ASSESSMENT REPORT

SYDNEY SOUTH PLANNING PANEL

PANEL REFERENCE & DA NUMBER	PPSSSH-110 [DA 2022/0061]
PROPOSAL	Demolition of existing structures, remediation and construction of an 8 to 18 storey mixed use development comprising 5 buildings consisting of retail and commercial uses and 349 residential apartments over 3 basement levels
ADDRESS	Lot 30 DP 785238 - 9 Gloucester Road Hurstville
APPLICANT	GTB Hurstville Pty Ltd (c/o Sutherland Planning)
OWNER	GTB Hurstville Pty Ltd
DA LODGEMENT DATE	24 February 2022
APPLICATION TYPE	Development Application
REGIONALLY SIGNIFICANT CRITERIA	Clause 2, Schedule 6 & Cl 2.19(1) of <i>State Environmental Planning Policy (Planning Systems) 2021</i> : Development that has a capital investment value of more than \$30 million
CIV	\$164,644,165 (excluding GST)
CLAUSE 4.6 REQUESTS	Building Height – Cl 4.3(2) of the Georges River LEP 2021
KEY SEPP/LEP	SEPP 65 and Georges River LEP 2021
SUBMISSIONS – NUMBER (TOTAL & UNIQUE) & KEY ISSUES	Five (5) unique submissions raising concerns including traffic Impacts and parking, privacy and overlooking, loss of natural light, impact on view, construction management and impacts (including asbestos), building height

Figure 71: Proposed publicly accessible areas (Source: Turner, March 2023)

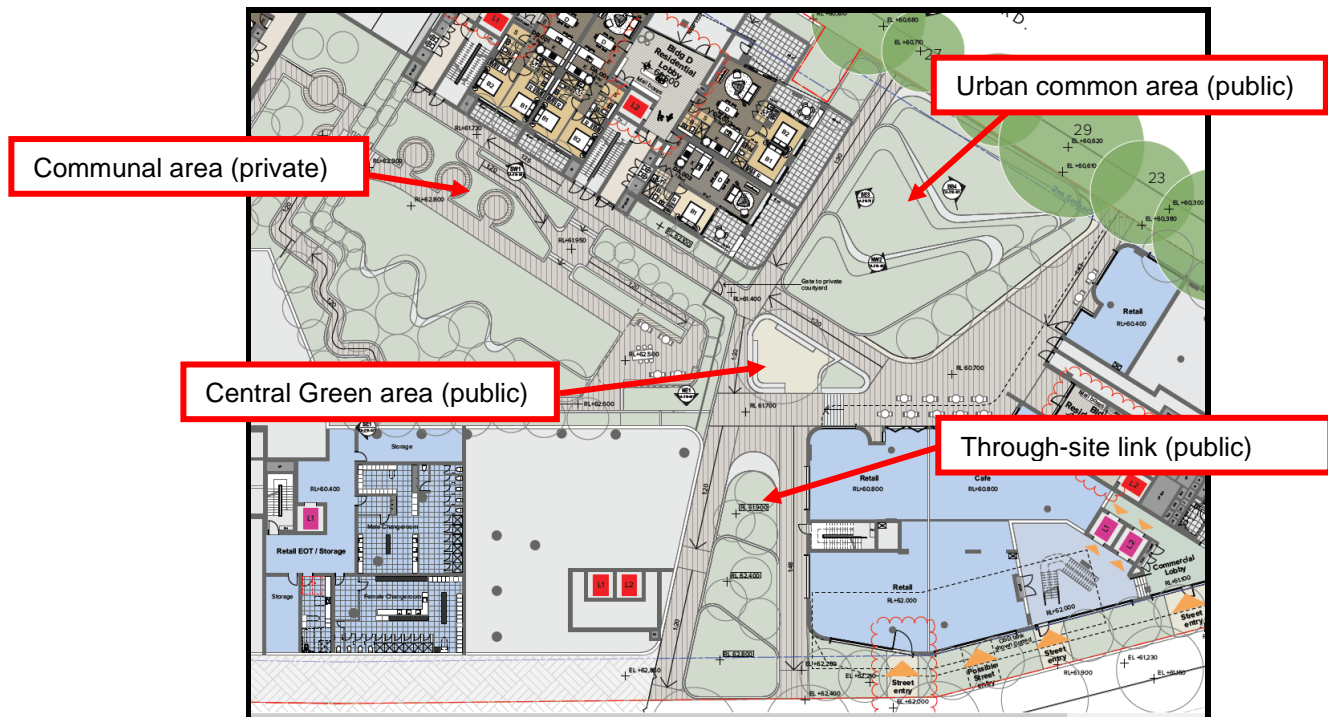
on the higher side of this link at level 1. This link provides for a clearly defined throughway for pedestrians and will provide public access 24 hours a day 7 days a week. The publicly accessible areas on the site are illustrated in **Figure 71**.

Apart from the open space areas remaining in private ownership, the application does not outline the management and ownership of the remaining areas of the site which are proposed to be publicly accessible. These areas would need to be maintained in perpetuity to a high standard, and it is unknown whether this is by way of strata title ownership by Council of the public space, or some other means. The application is unsatisfactory in that there is inadequate information on the future ownership and management of the publicly accessible areas on the site.
